ADDENDUM TWO

Addendum Two (AD.02) to the drawings and specifications prepared by Gibraltar Design for **Maconaquah HS – Piping Replacement & Related Work** for Porter Township School Corporation, Valparaiso, Indiana.

GIBRALTAR DESIGN SHEET
MD101

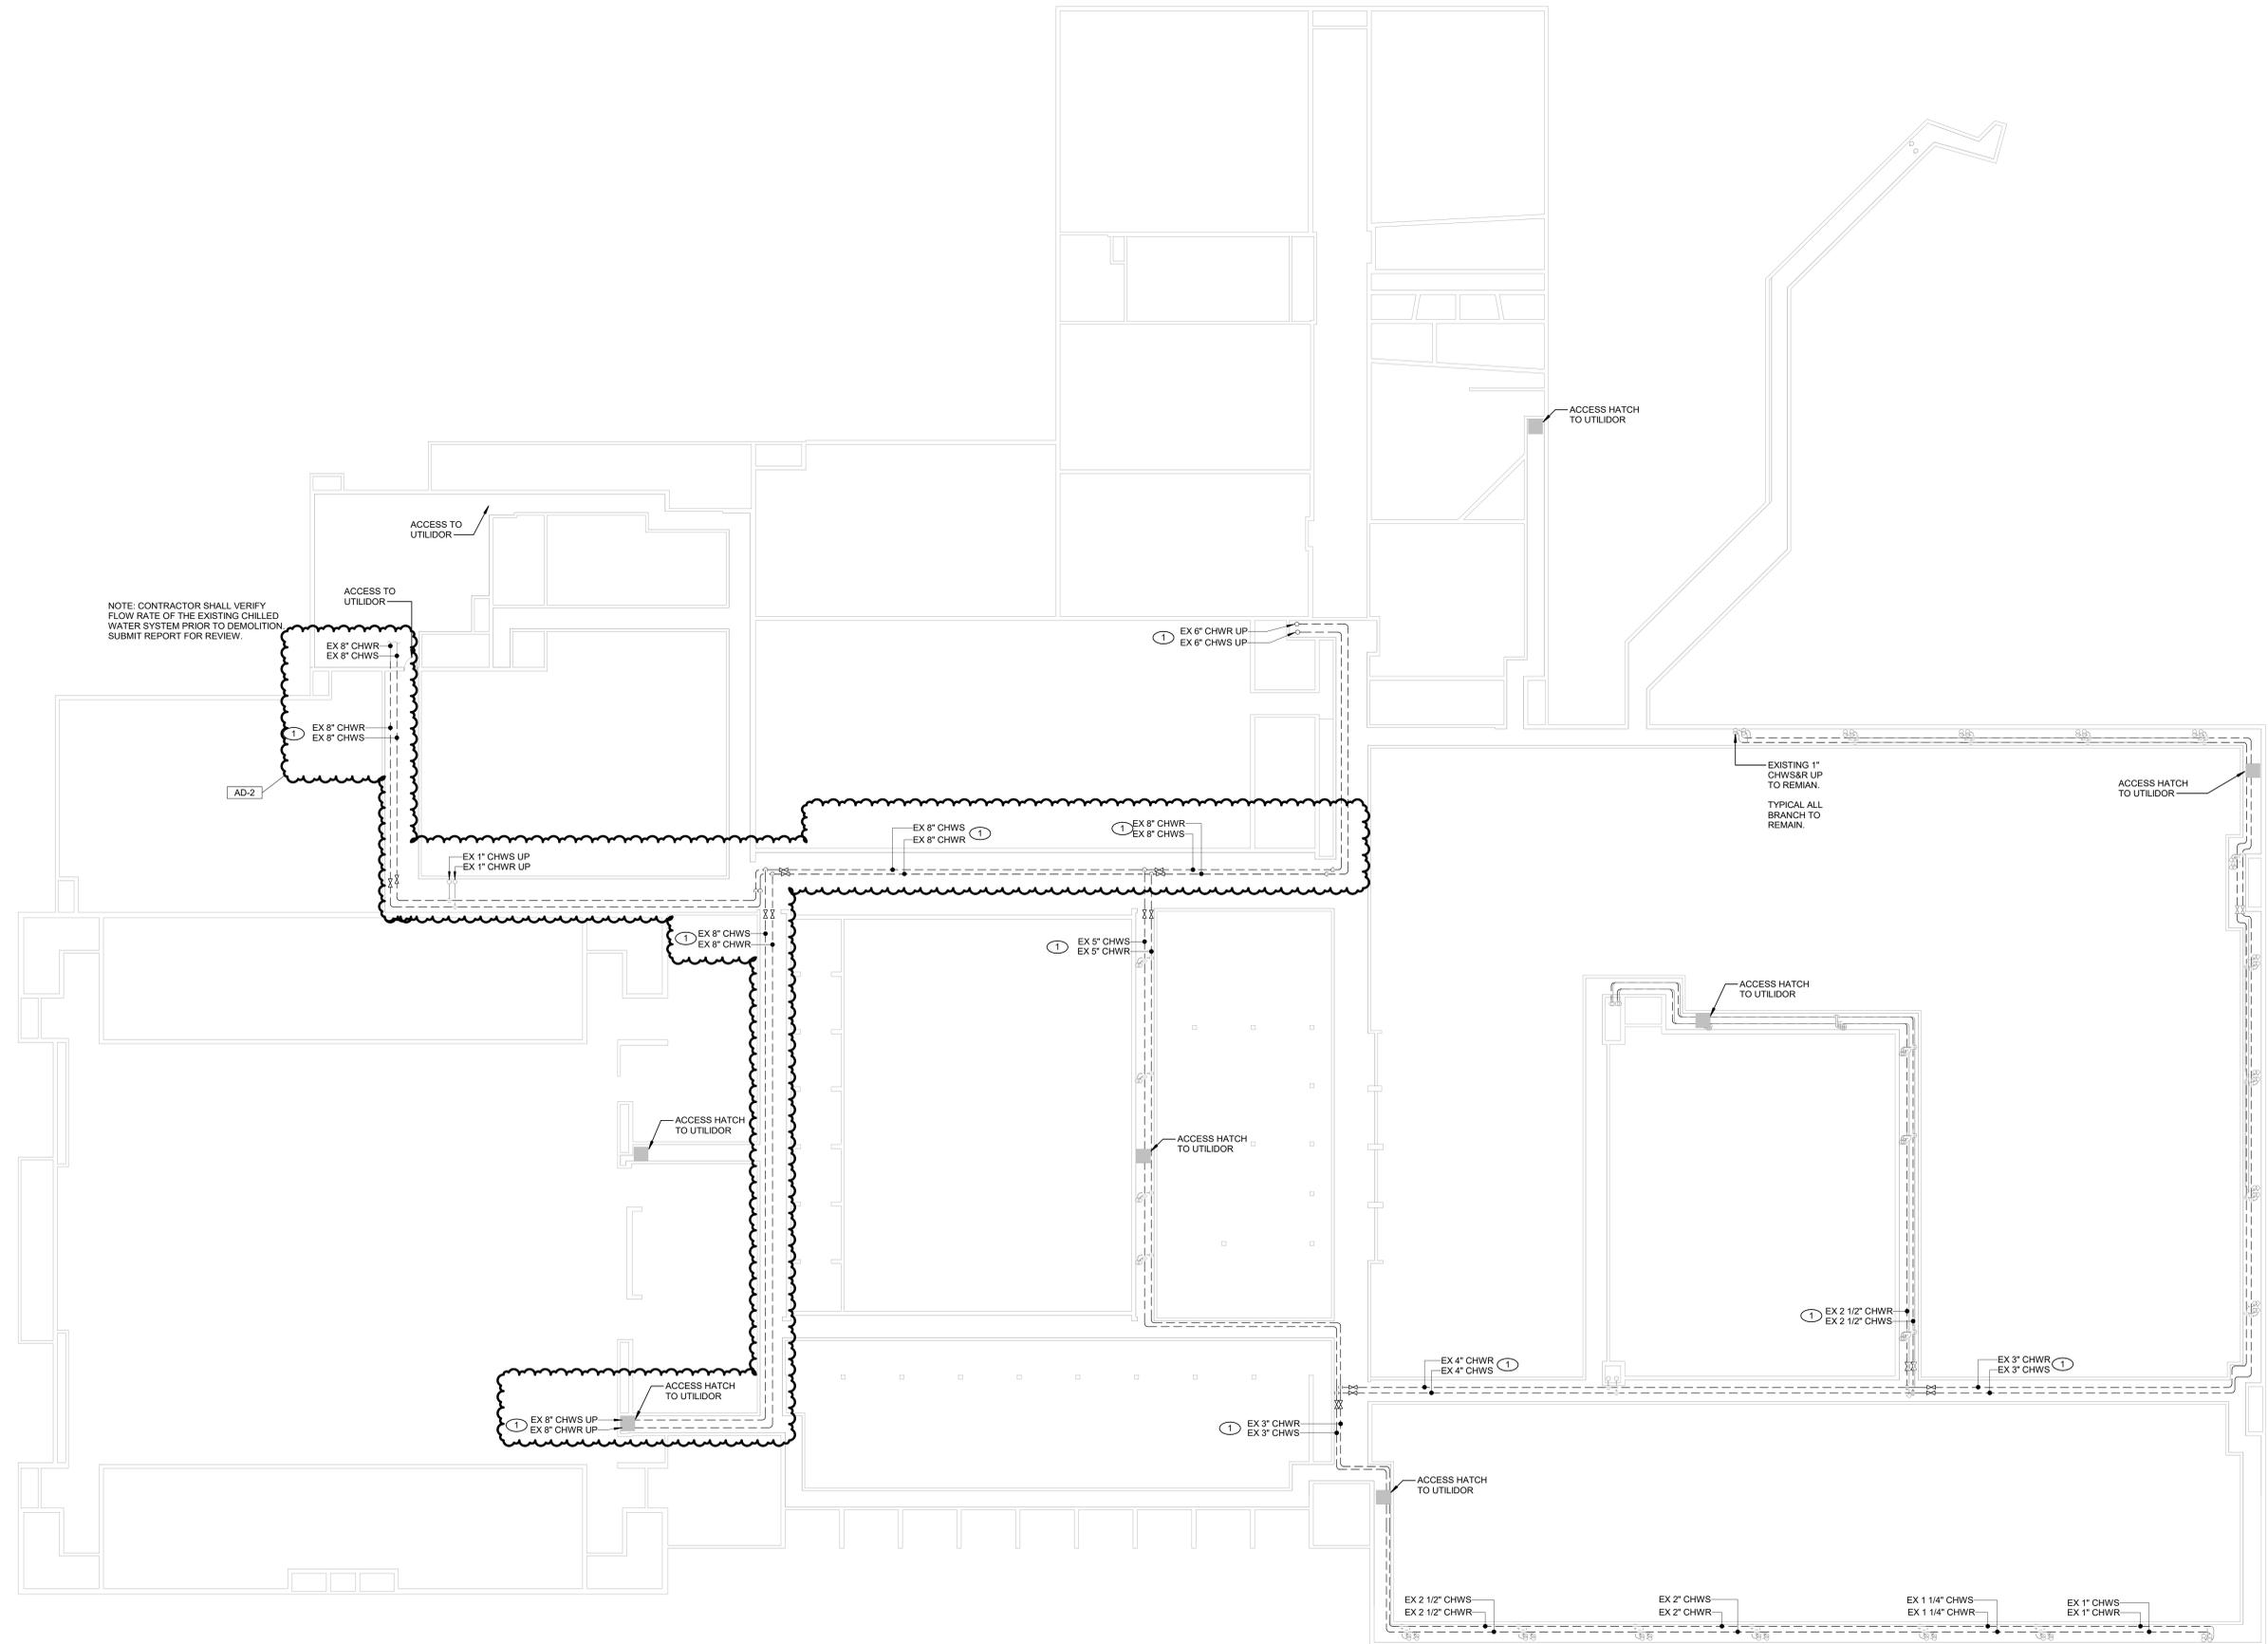
- A. Changed existing chilled water supply/return piping from 6" to 8" pipe. Also showed an existing tap location.

SHEET: M-102

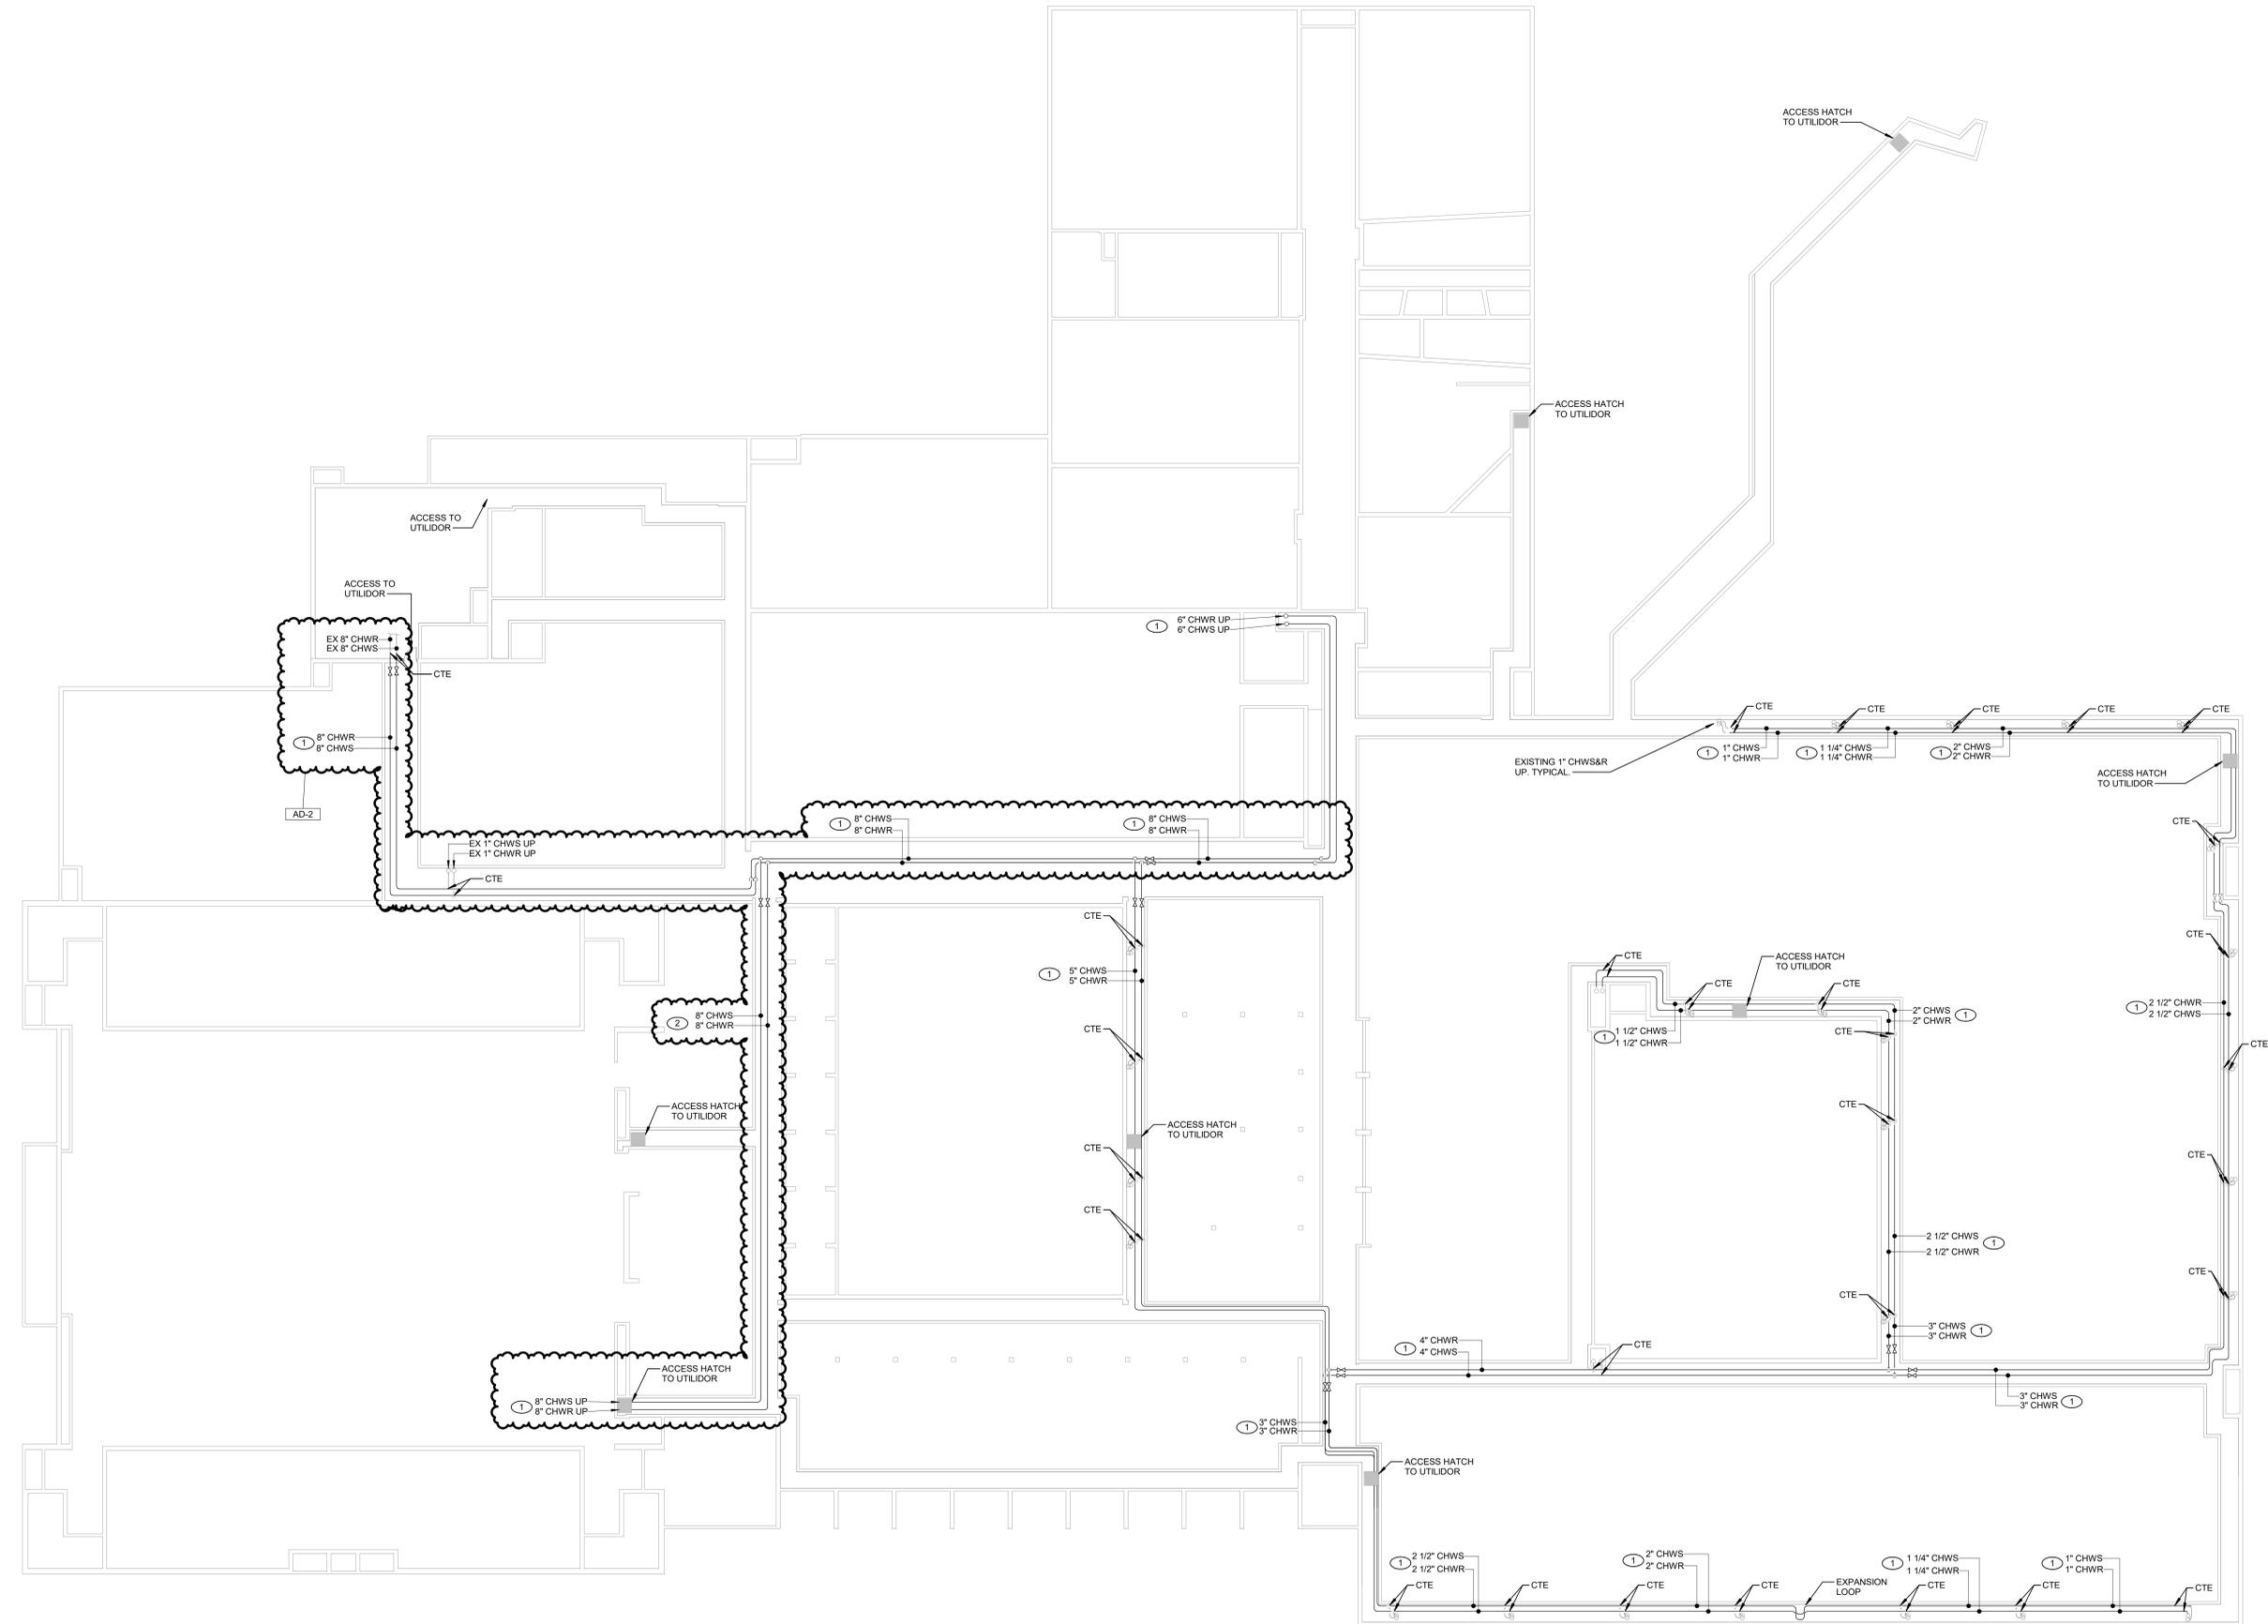
- A. Changed chilled water supply/return piping from 6" to 8" pipe. Also showed an existing tap location.
